RESPONSE TO AUDIT ISSUES

APR1400 Topical Reports

Docket No. PROJ0782

Review Section	TR Realistic Evaluation Methodology for LBLOCA of the APR1400
Application Section	Topical Report: APR1400-F-A-TR-12004 Realistic Evaluation Methodology for Large-Break LOCA of the APR1400
Issue Date	08/13/2015

Figure 17 RELAP5 Noding Diagram for APR1400

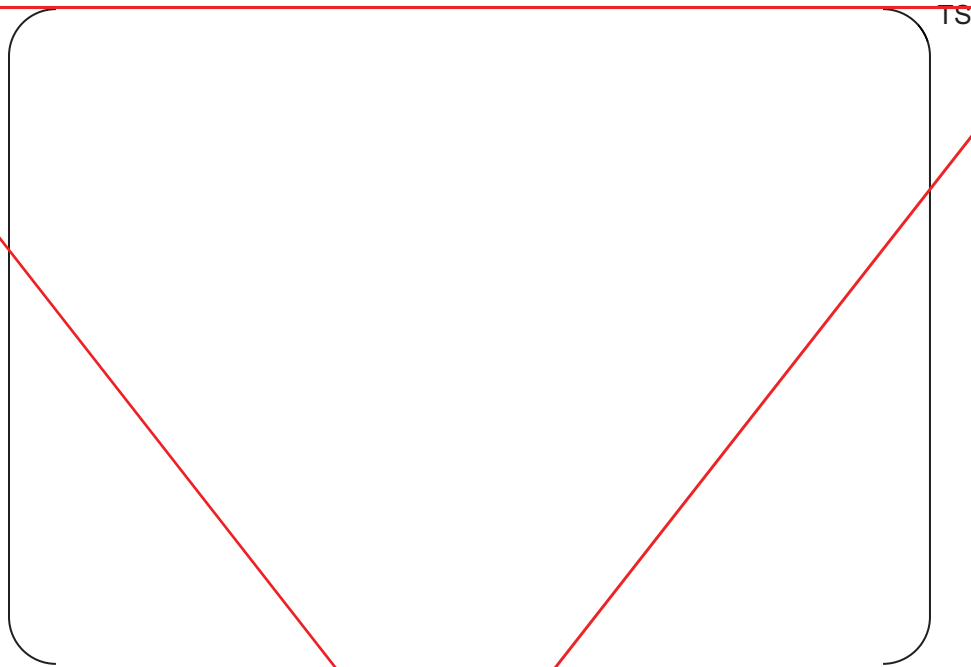
- I. Discuss the differences in the nodalization of the upper guide support structure region between the RELAP5 nodalizations shown in Figure 4-1 of the topical report, and Figure 17 in Appendix B. Identify, with justification, the nodalization that will be used for licensing calculations.

Figure 17 in Appendix B is used only to study sensitivities for code modifications. Nodalization of Figure 17 in Appendix B was used during developing phase of the CAREM.

However, it is reasonable to use same nodalization for all sensitivity study. Therefore, revision of topical report will be included re-calculation results of sensitivity study using same nodalization of APR1400.
